**TOWN OF NEWBURGH  
PLANNING BOARD  
REVIEW COMMENTS**

**PROJECT: DEPEW ENERGY COMPANY AMENDED SITE PLAN**  
**PROJECT NO.: 14-09**  
**PROJECT LOCATION: SECTION 43, BLOCK 5, LOTS 41.2 & 42**  
**PROJECT REPRESENTATIVE: ENGINEERING & SURVEYING PROPERTIES**  
**REVIEW DATE: 29 AUGUST 2014**  
**MEETING DATE: 4 SEPTEMBER 2014**

**RE: DEPEW ENERGY CO.  
RTE 9W SITE PLAN AMENDMENT  
TAX LOT # 43-5-41.2 & 42**

**DETAILS**

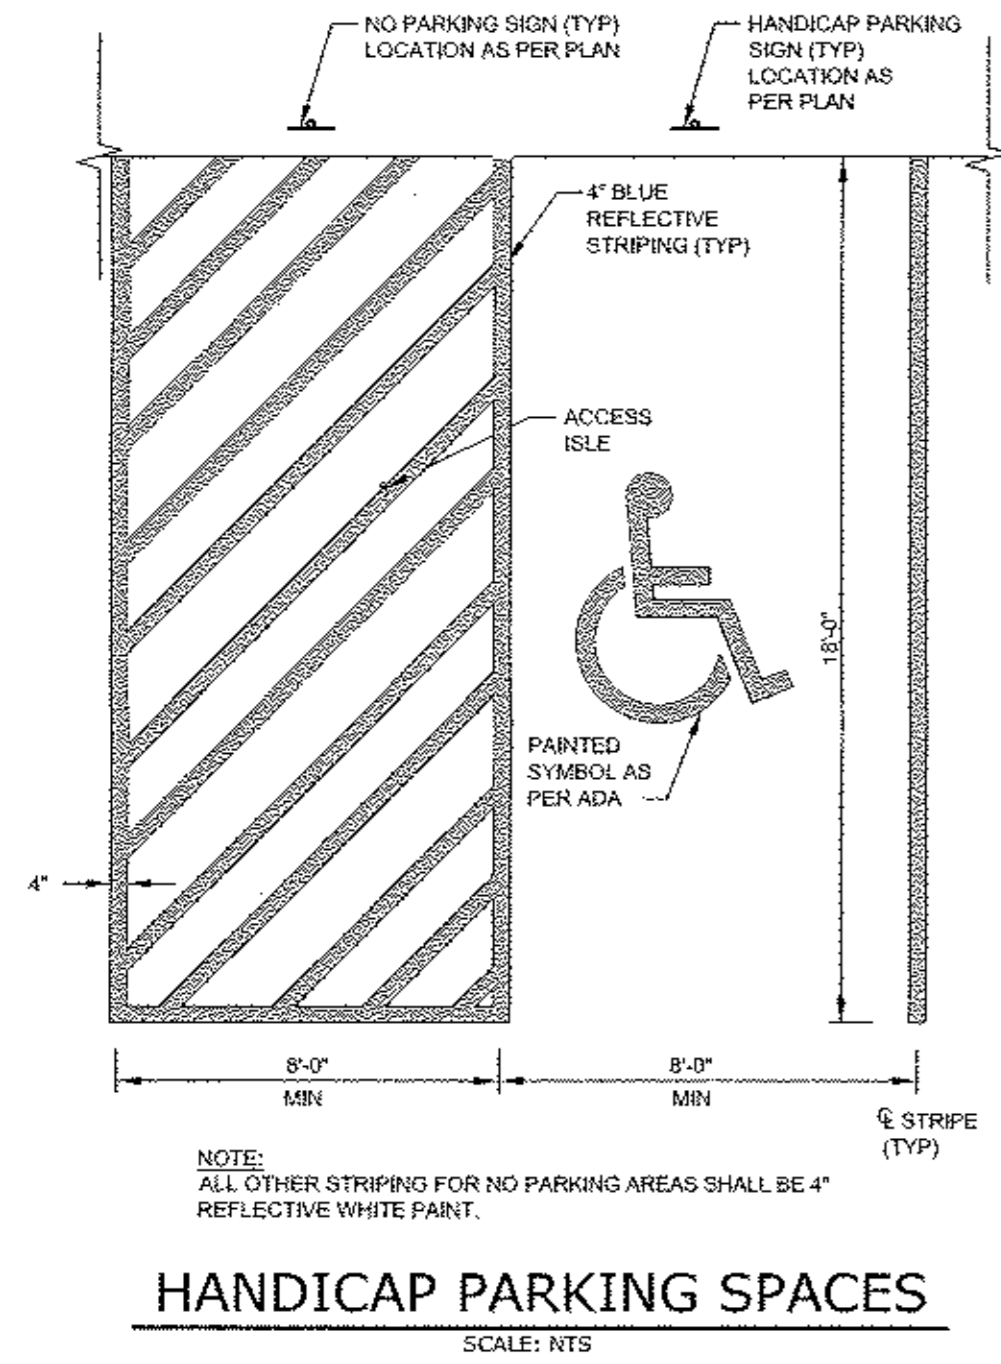
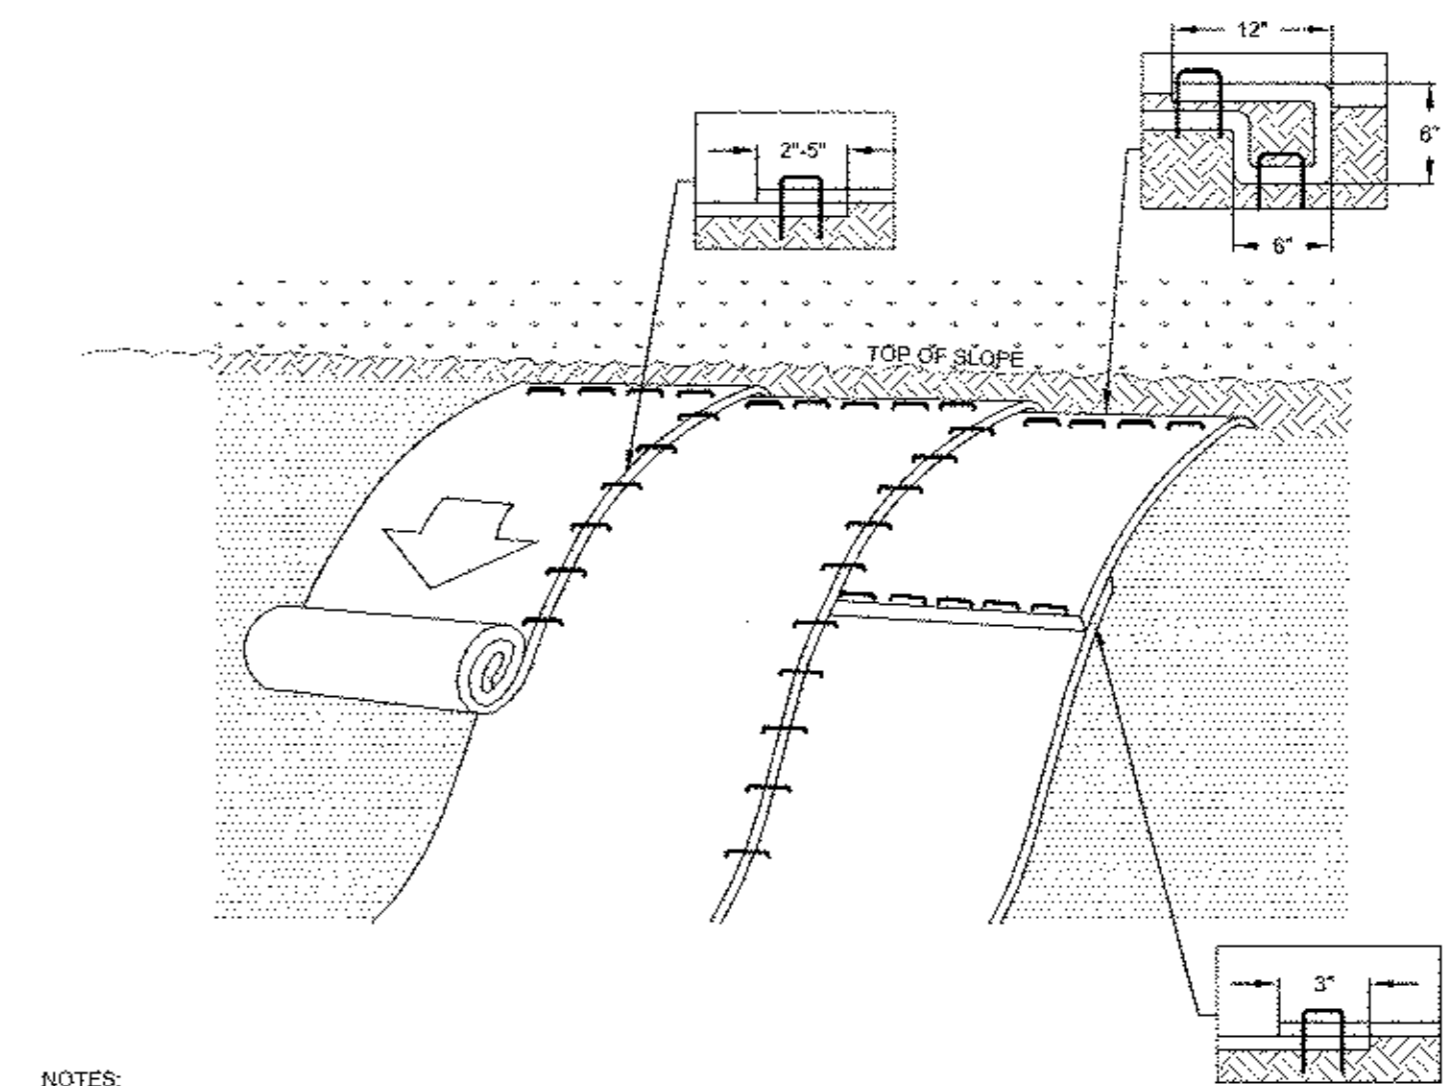
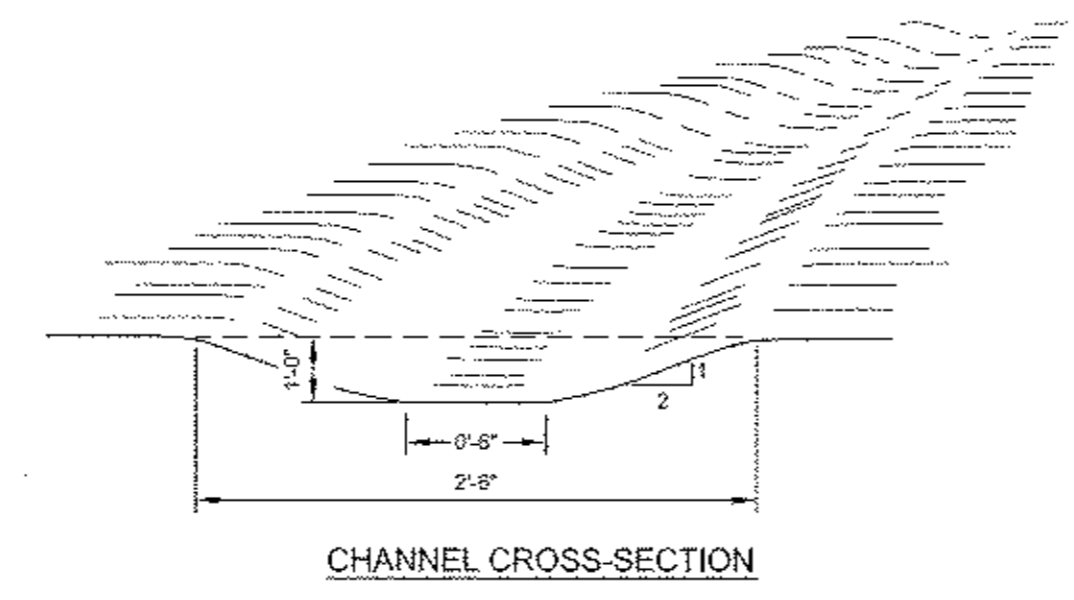
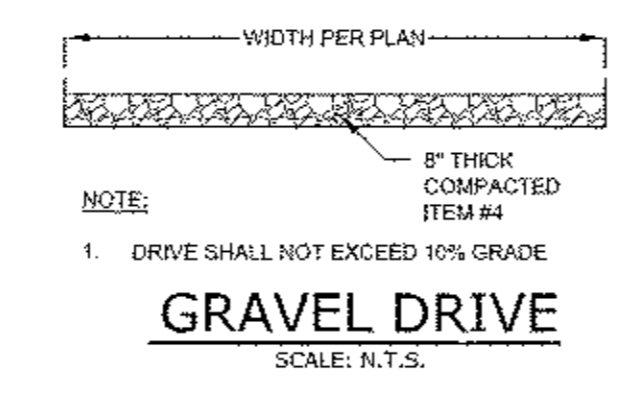
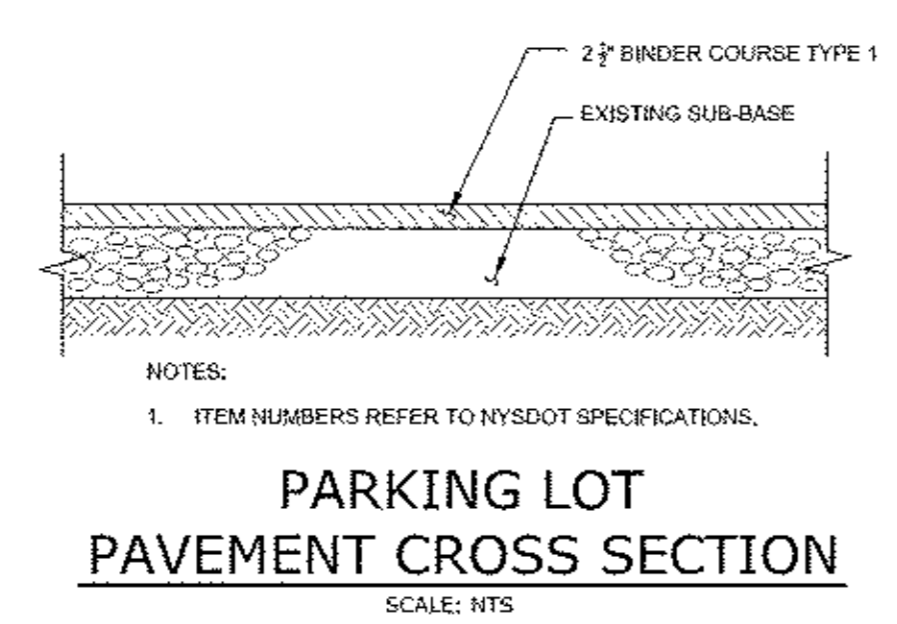
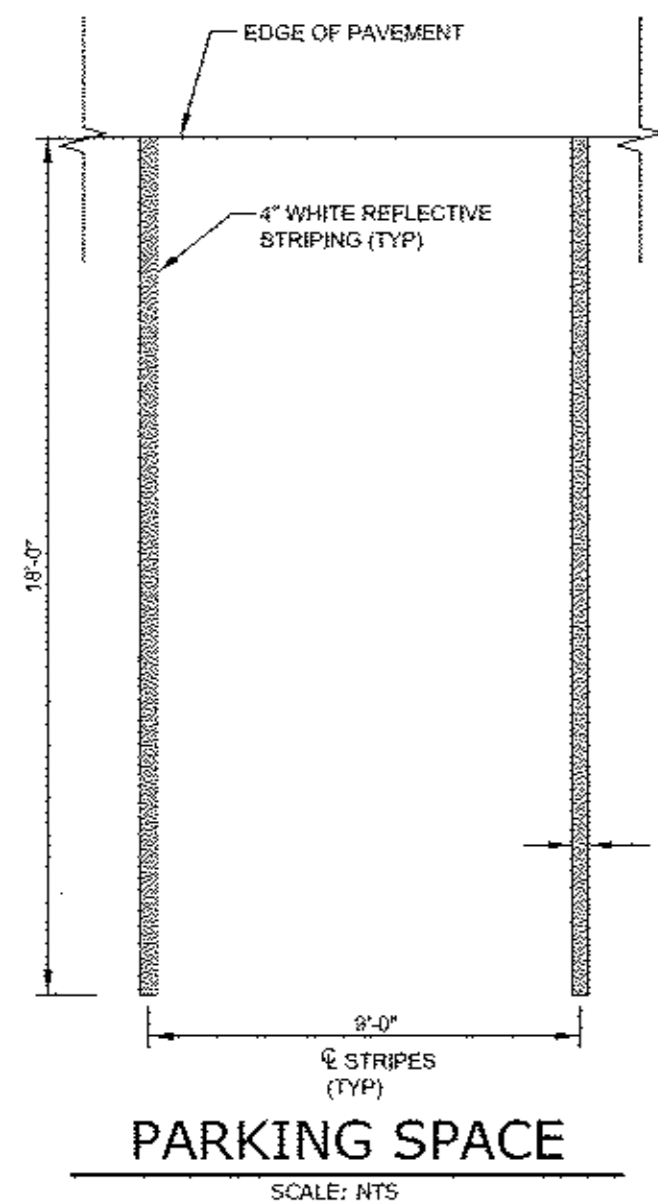
5. Handicap parking spaces do not appear to comply with details depicted on detail sheet and ADA requirements. Striping for the handicap parking must be in compliance with detail provided.

6. Striping details should be revised to Town of Newburgh standard. Double striping is required.
7. Mike Donnelly's review of the deed restriction regarding the creation of the unified site plan across two lots should be provided.
